City of  
Richmond

## Report to Development Permit Panel

**File:** DP 17-776441

**Re:** **Application by Bismark Consulting Ltd. for a Development Permit at 7000/7002,  
7020 Williams Road & 10060 Gilbert Road**

Drawing Title:  
**ROOF & ROOF DECK PLAN**

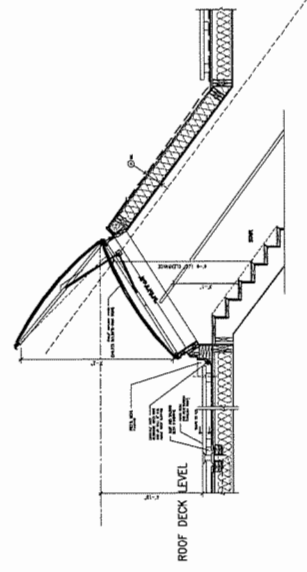
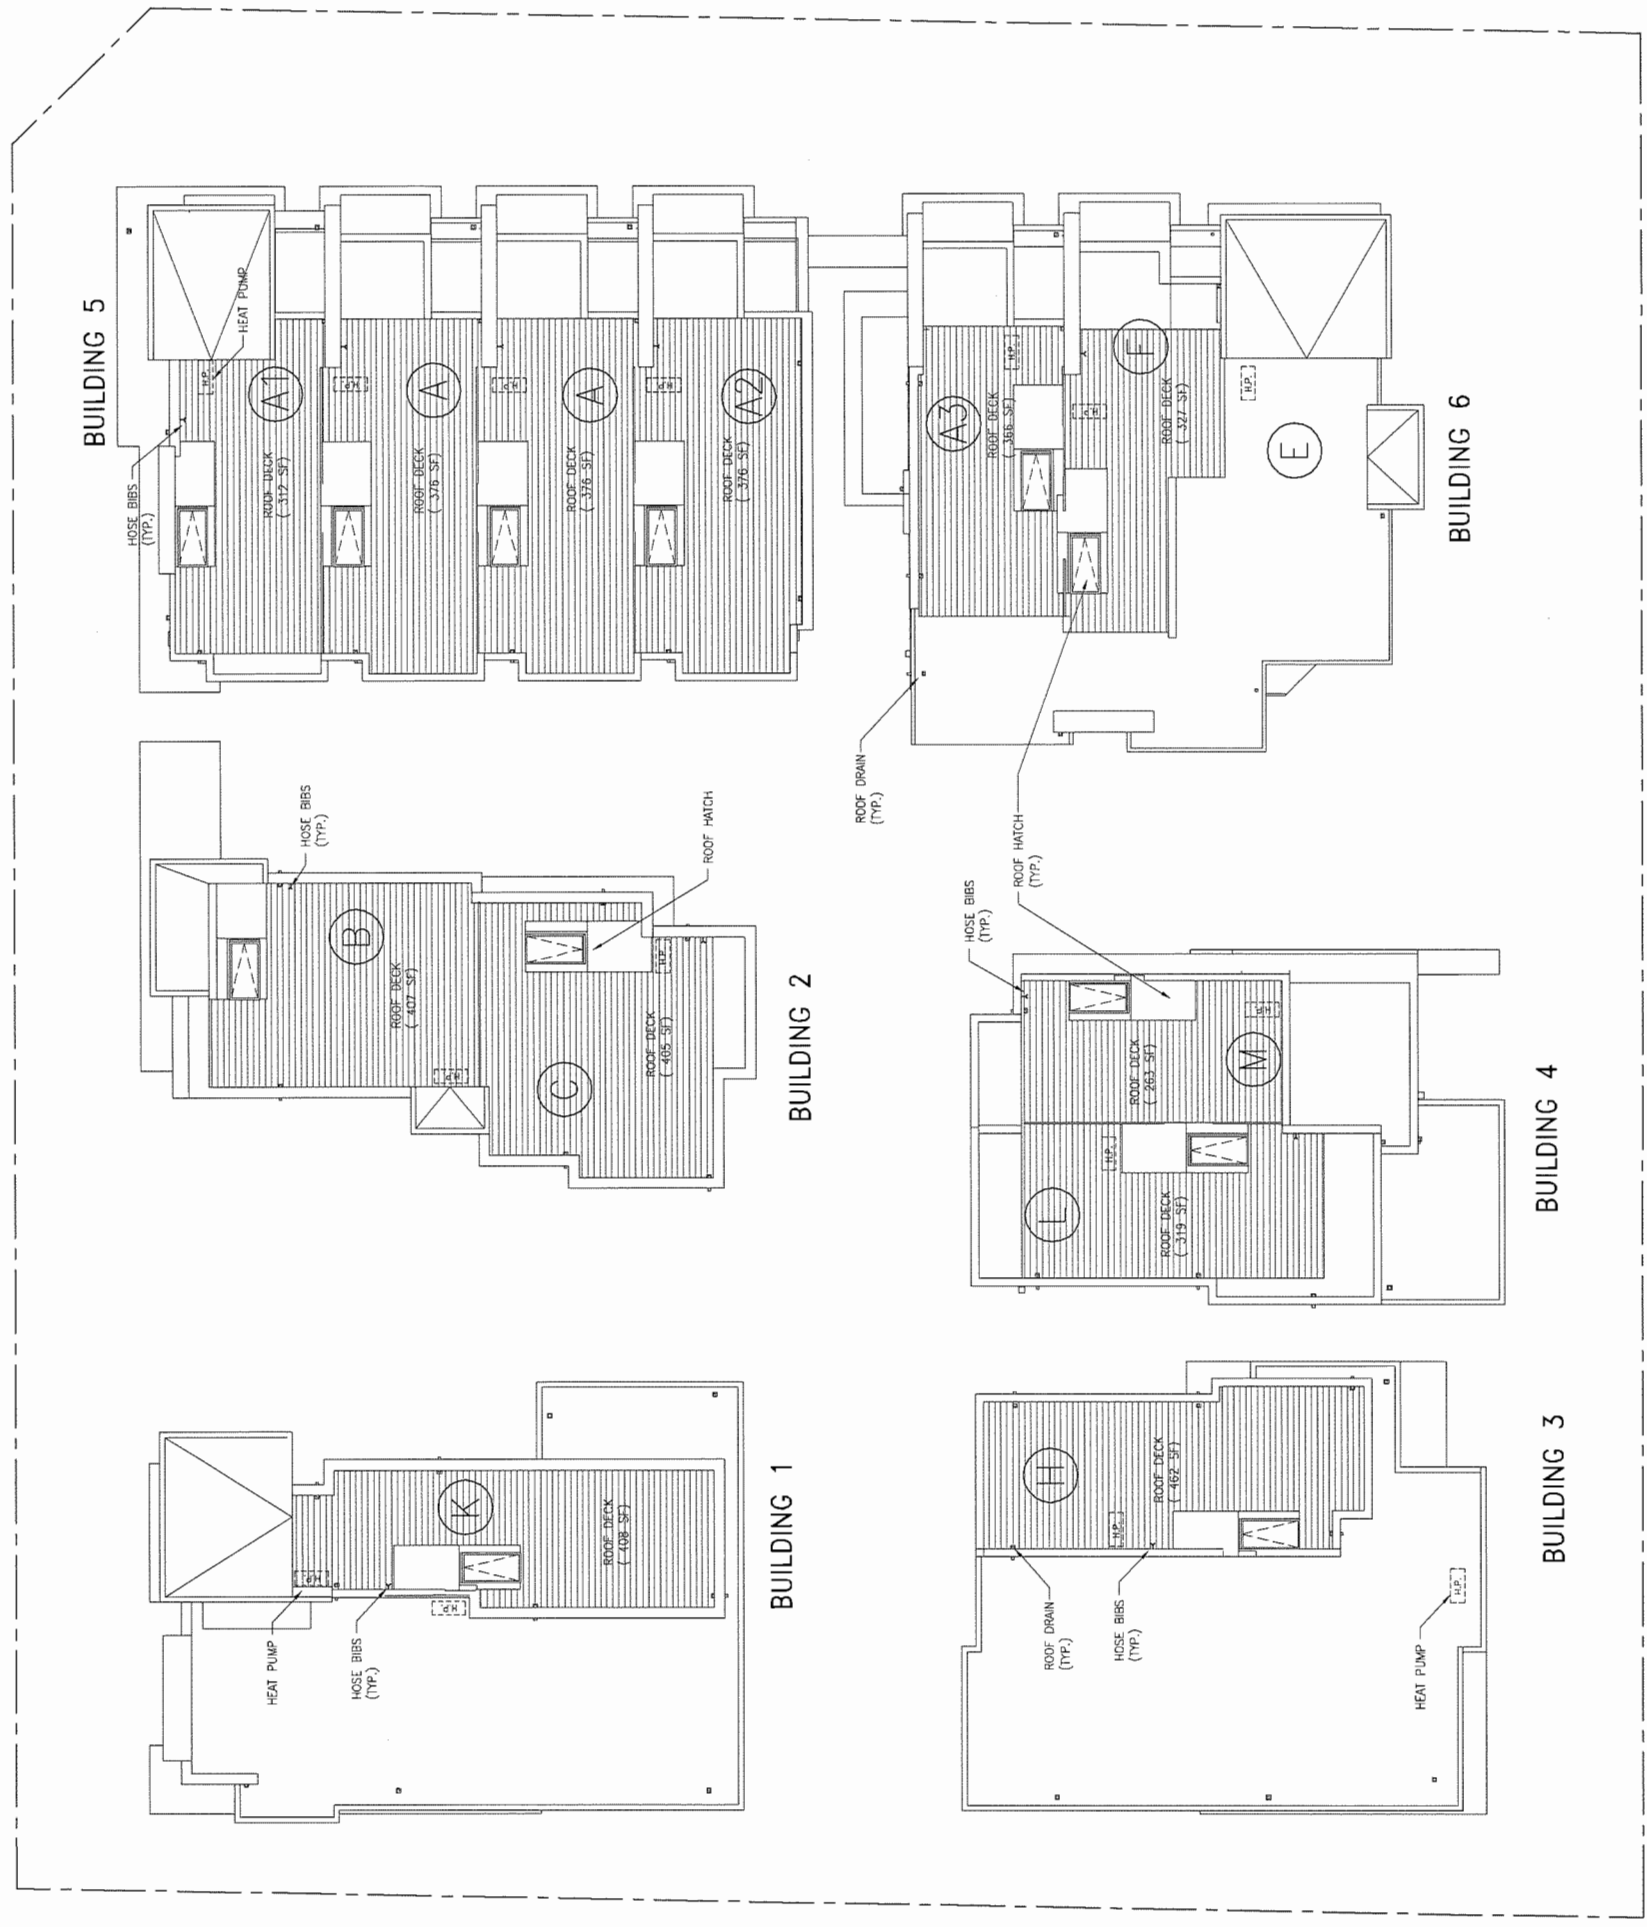
- details of the roof hatch on roof plan A3-R are not accurate; review and revise the drawing to show the correct way the roof hatch is opened;

***The roof plan is revised with the swing door lines removed.***

AMENITY AREA - ENLARGEMENT  
SCALE: 3/16"=1'-0"

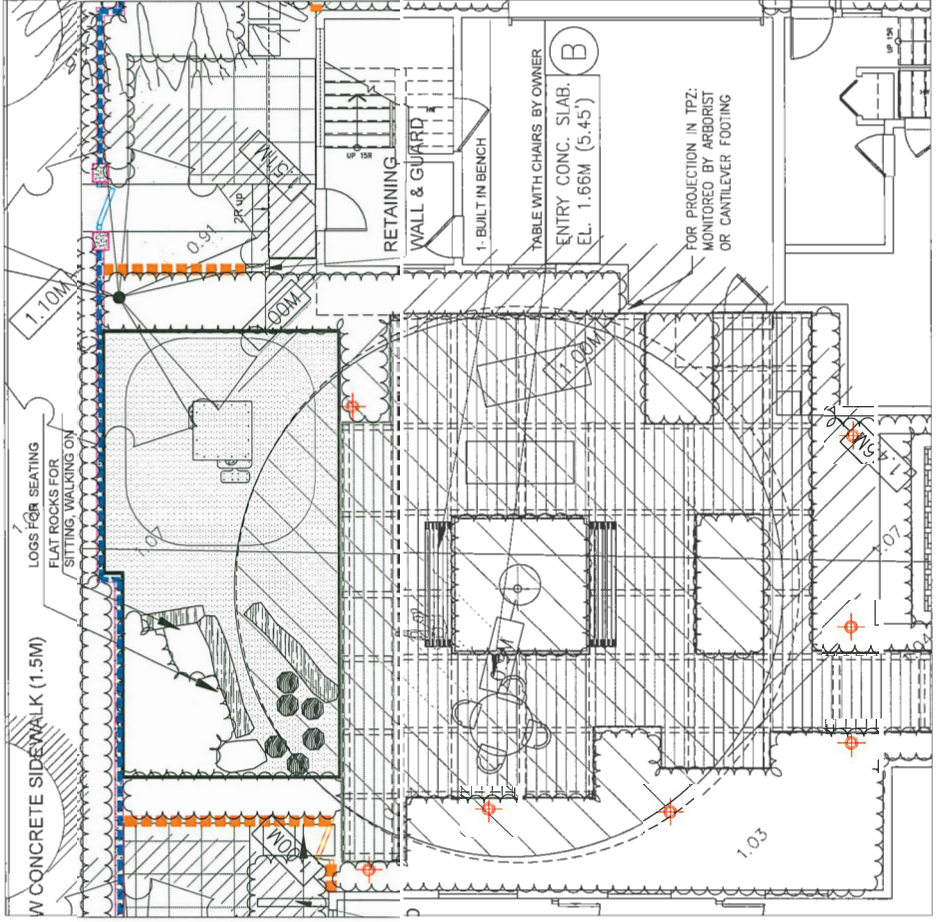
- materials in the outdoor amenity area appear to be in the wrong place; consider relocating the wood deck away from the existing tree to the shady area where the lawn is currently located and provide landscaping around the tree; will provide relief to the tree as the compacted concrete beams underneath the wood deck may negatively impact the tree roots; consider pushing the lawn out into a sunnier area within the outdoor amenity area;

- the design of the outdoor amenity area does not currently appear organic; relocating the wood deck to the current lawn area (area E) will provide a softer transition of materials from lawn (in lieu of the wood deck) to fibar and create a more organic feel to the outdoor amenity area; consider using the balancing beams and stepping stones to define the edges between the lawn and fibar;

DRAWING TITLE:  
**GRADING PLAN**

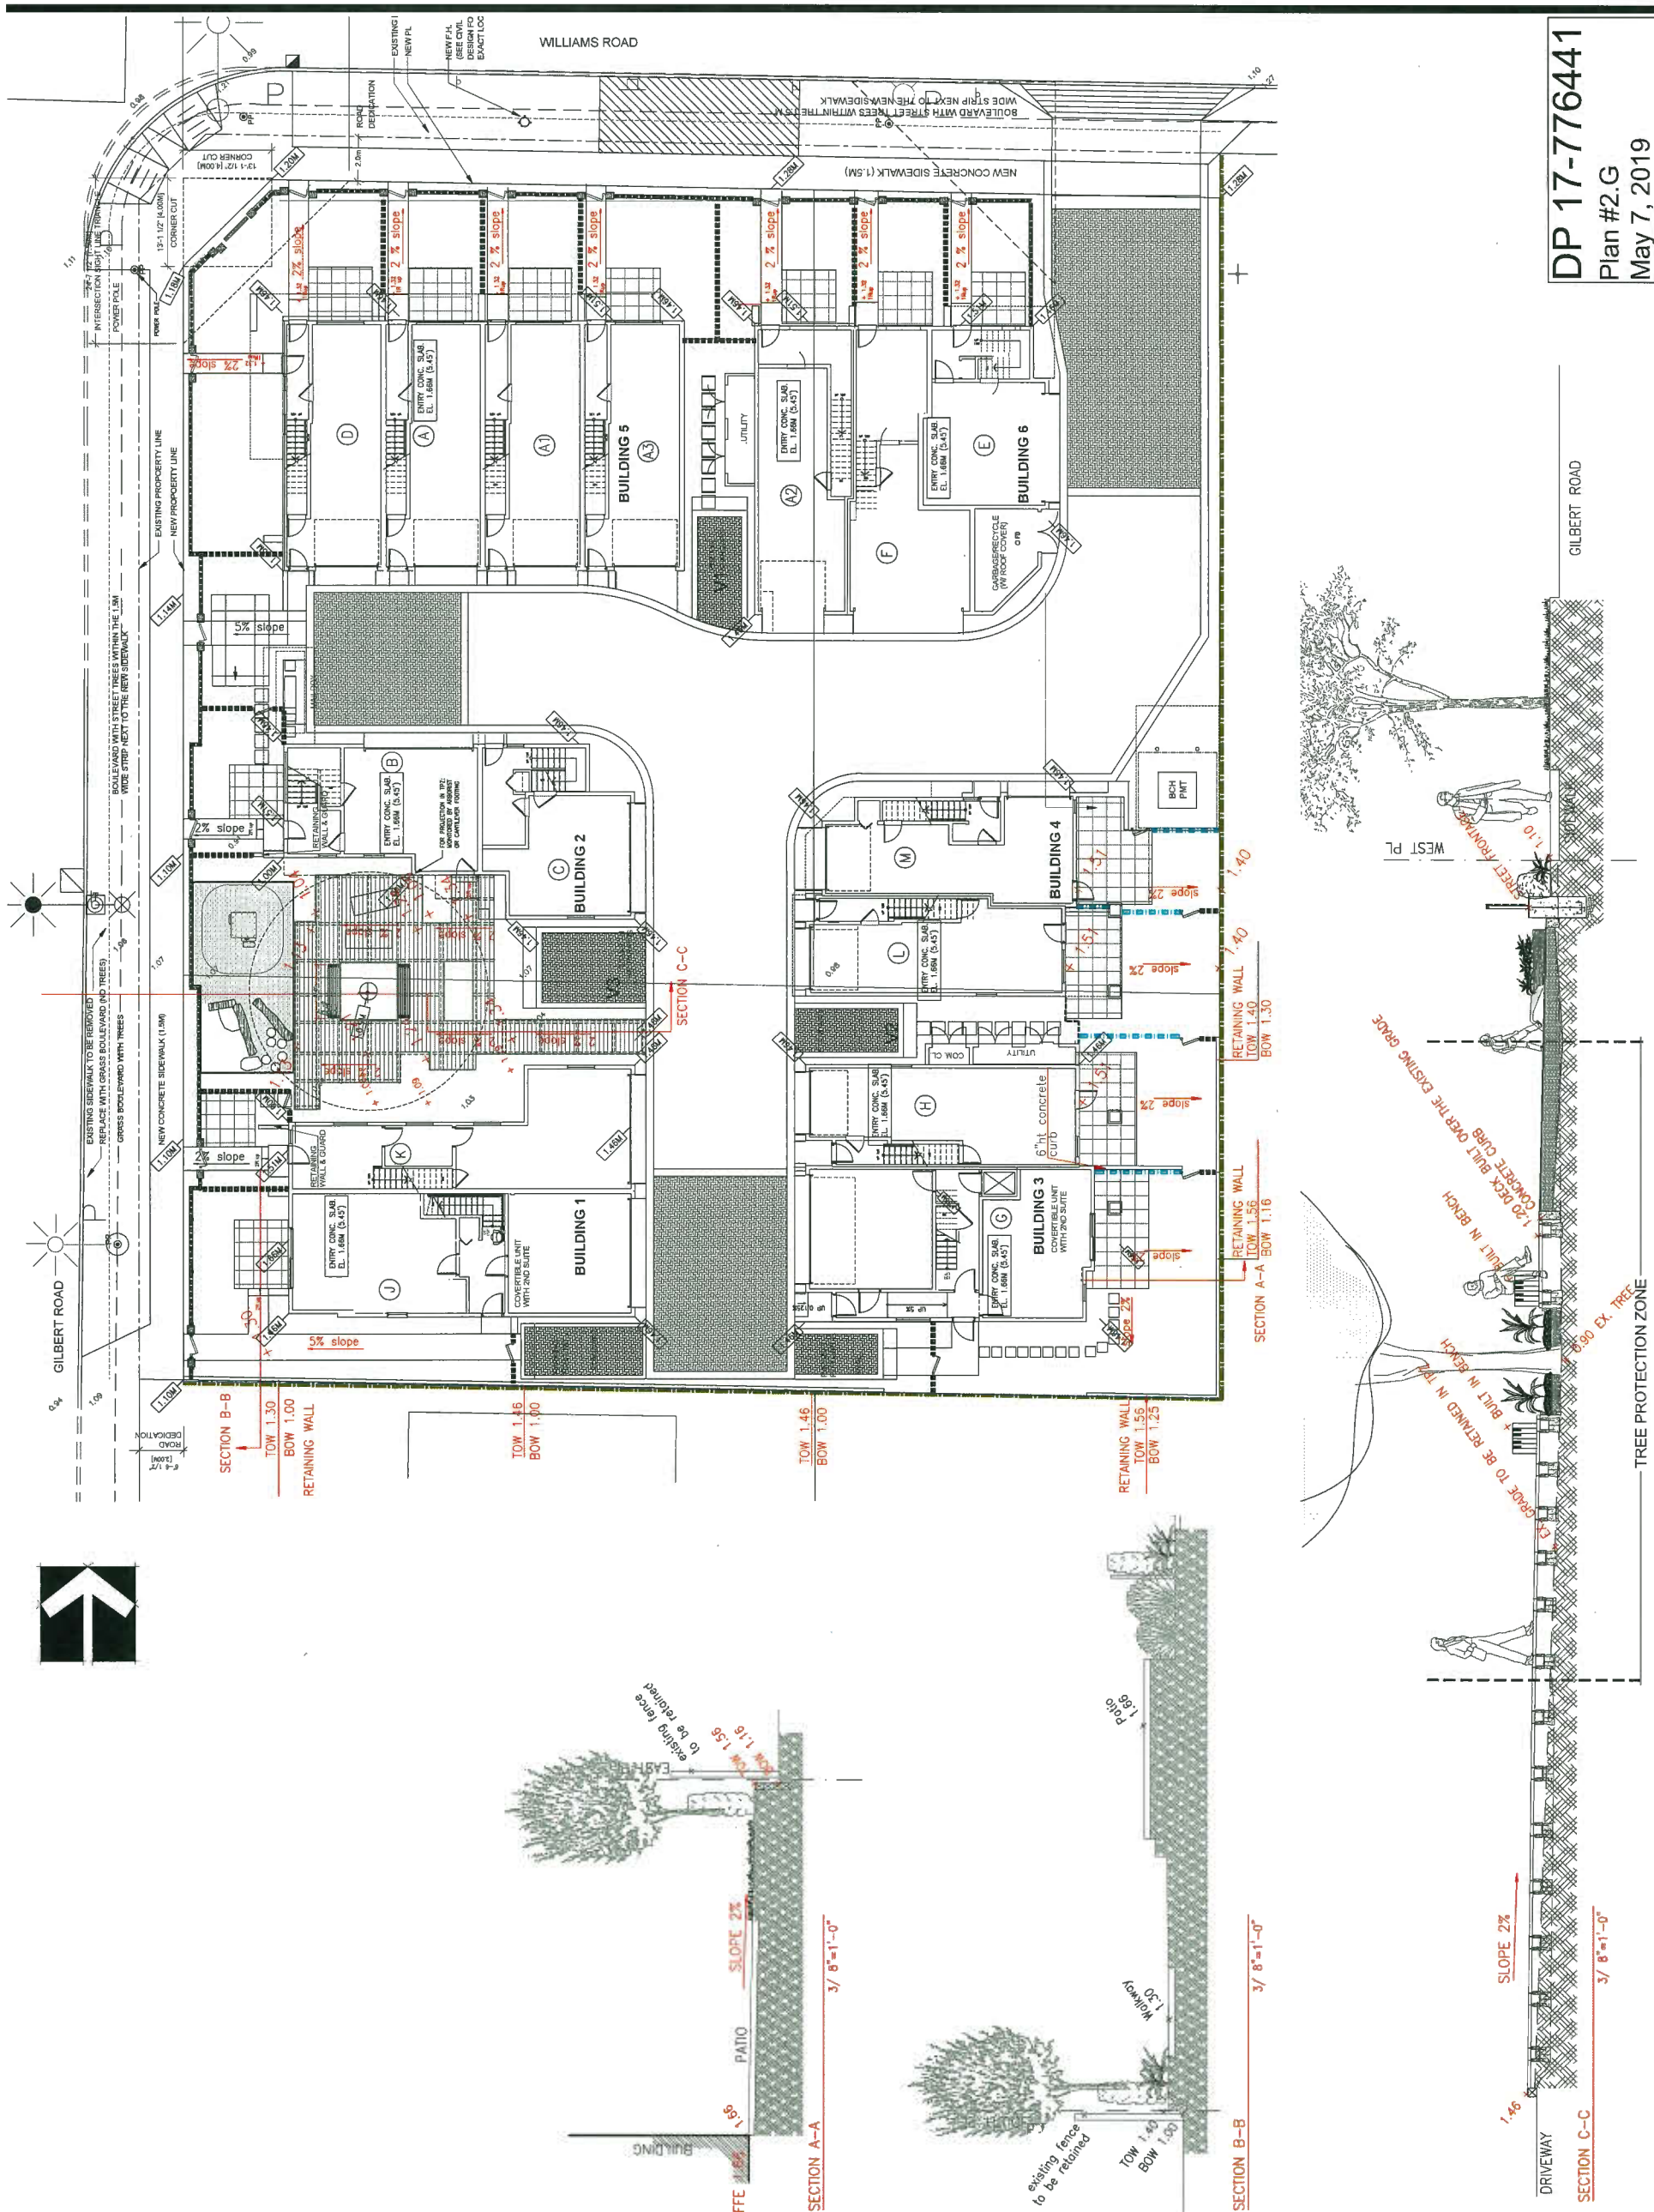
*See updated tree management plan.*
- a grading plan was missing from the package;

*Key grading data are shown on the architectural Site Plan (Sheet A1). More detailed grading plans are to be provided by project civil engineer and/or landscape architect.*
- the planting plan provided by the applicant is not legible;

STREETSCAPE ALONG WILLIAMS ROAD

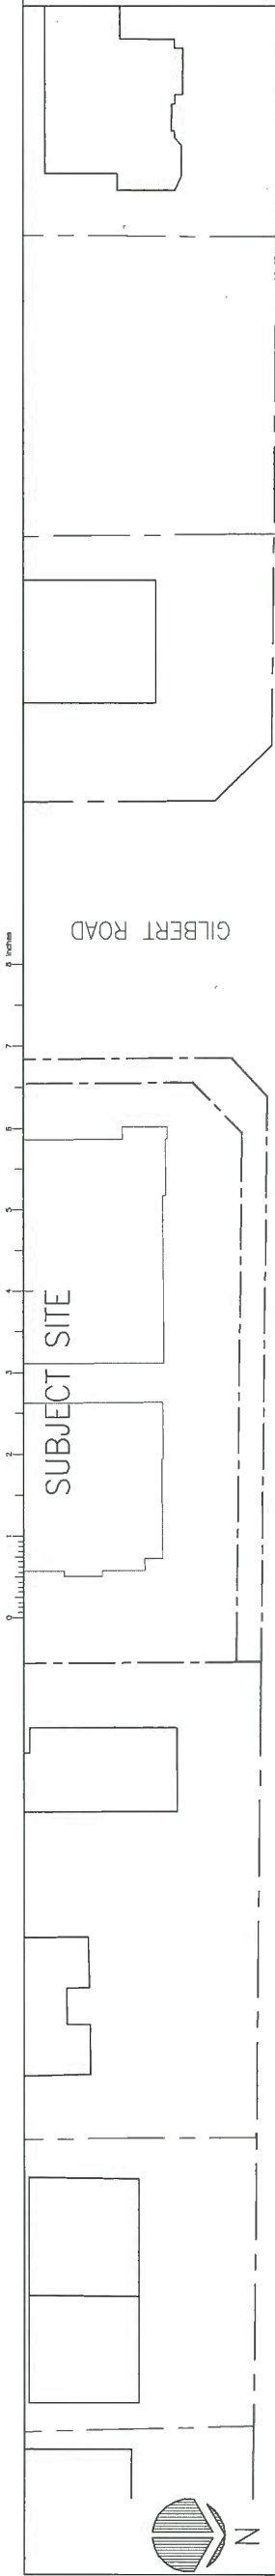
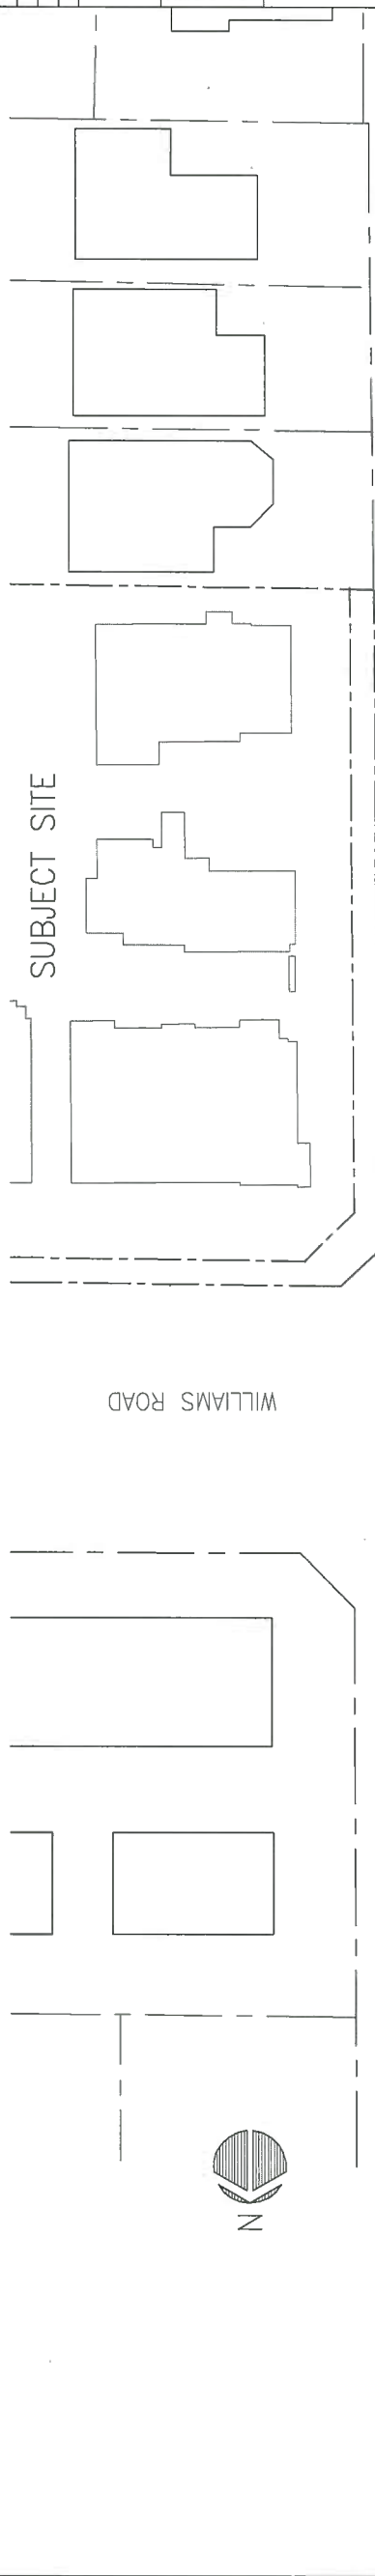
*Roof drains have been studied and designed. All roof drains are lead to exterior rainwater leaders and no interior stormwater is proposed (see updated Roof Plan and Elevations).*
- Panel appreciates the contemporary design of the project; the project is located in a high visibility area; more details on the site context would have been helpful to the Panel;

*Site context and streetscape are studied. Sheets A0.1 & A0.2 show the Streetscape elevations, Context plans and photos of the neighborhood.*
